ILLINOIS POWER COMPANY

Clinton Power Station Unit 1  
Docket No. 50-461

ELEVATION OF WATER LEVEL IN THE UNIT 2 EXCAVATION  
DUE TO LOCAL PROBABLE MAXIMUM PRECIPITATION (PMP)

FIGURE A

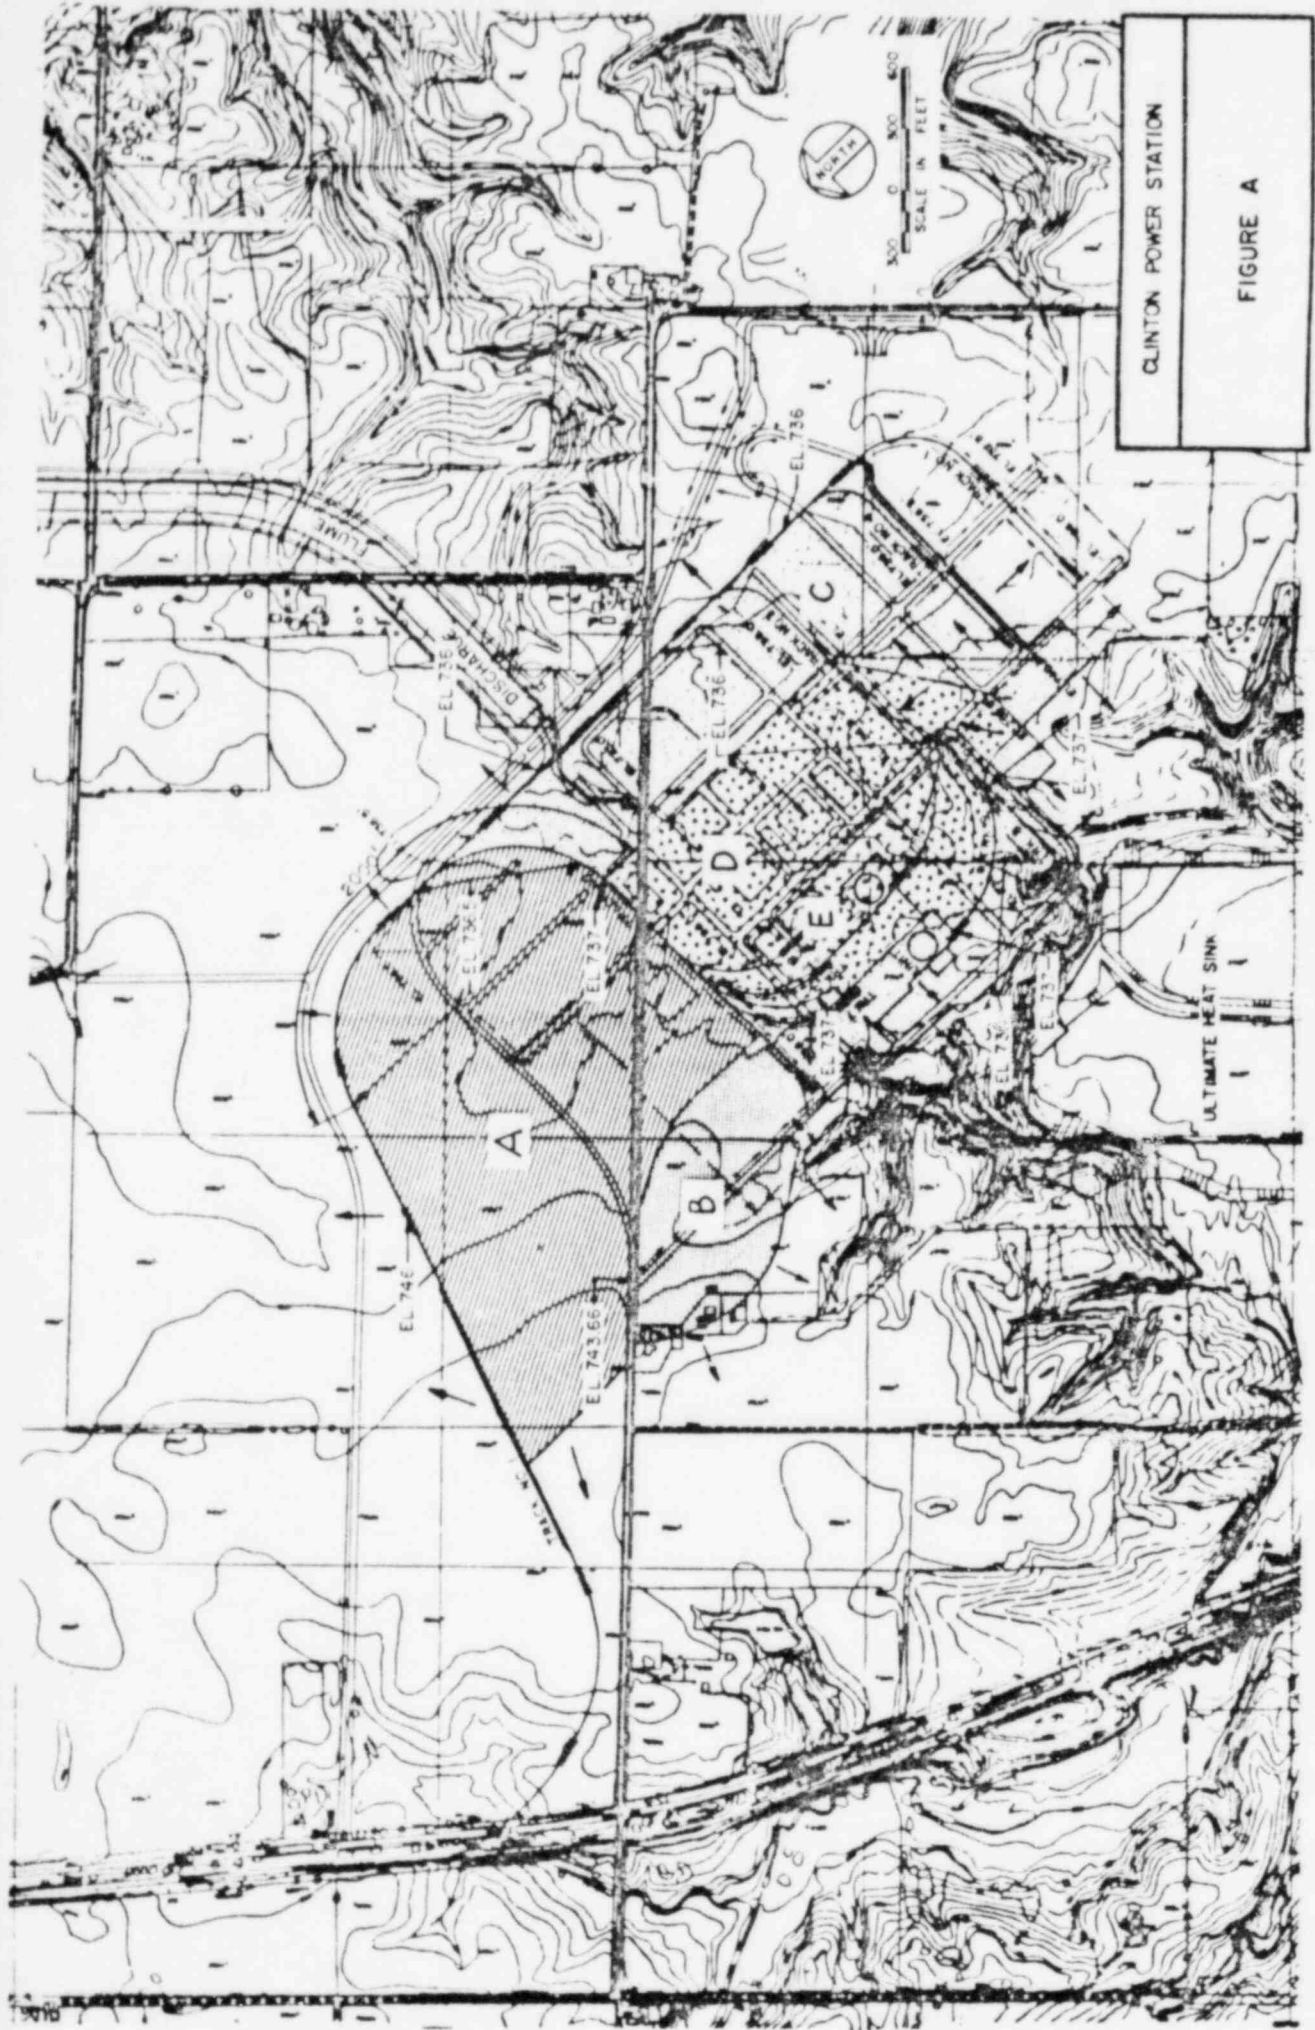
The area surrounding the Unit 2 excavation is shown in the attached Figure A. This area is divided into five zones, A through E. It is assumed that the earth berms surrounding the excavation are, ineffective, no drainage takes place from the excavation, and the plant underground drainage system is ~~ineffective.~~ *not functional.*

Zone A has an area of 75 acres and drains east over a 2,000-foot long portion of a railroad track with a top of rail elevation 736.5 or lower. During a local PMP, the peak discharge from this area is estimated as 1,470 cfs, which would produce a maximum water level of 736.94 feet. The top of rail of the track south of Zone A, which separates this zone and the Unit 2 excavation, is at elevation 737.0 feet. Hence, Zone A does not contribute any runoff to the Unit 2 excavation.

Zone B drains west and away from the Unit 2 excavation and does not produce a maximum water level above elevation 737.0 feet. Hence, this zone also does not contribute runoff into the excavation.

Zone C also drains away from the excavation towards east and west, as shown in Figure A. The top of the peripheral roads and railroad track for Zone C are at elevation 736.0 feet or lower, and the maximum water level in this area during a PMP would be lower than elevation 737.0 feet. Therefore, the runoff from this zone does not contribute to the runoff into Unit 2 excavation.

The volume of water that could accumulate in Unit 2 excavation is the runoff from Zone D and the direct rainfall on the excavation itself. Since the top of the plant road east of the Unit 2 excavation and the top of rail on the east perimeter track of Zone C are at elevation 736.0 feet, the eastern limit of Zone D was selected midway between the road and track. The total area of Zones D and E is 44.2 acres, and assuming no losses, the 48-hour PMP of 33.6 inches on this area will produce a runoff volume of 124 acre feet. This volume is a conservative estimate, and it would produce an impounded water elevation of 726 feet in the Unit 2 excavation without the protecting effect of the surrounding earth berms, and without the benefit of any drainage out of the excavation. This elevation of 726 feet is lower than the 730 feet elevation considered in the hydrostatic design of the Unit 1 exterior walls.
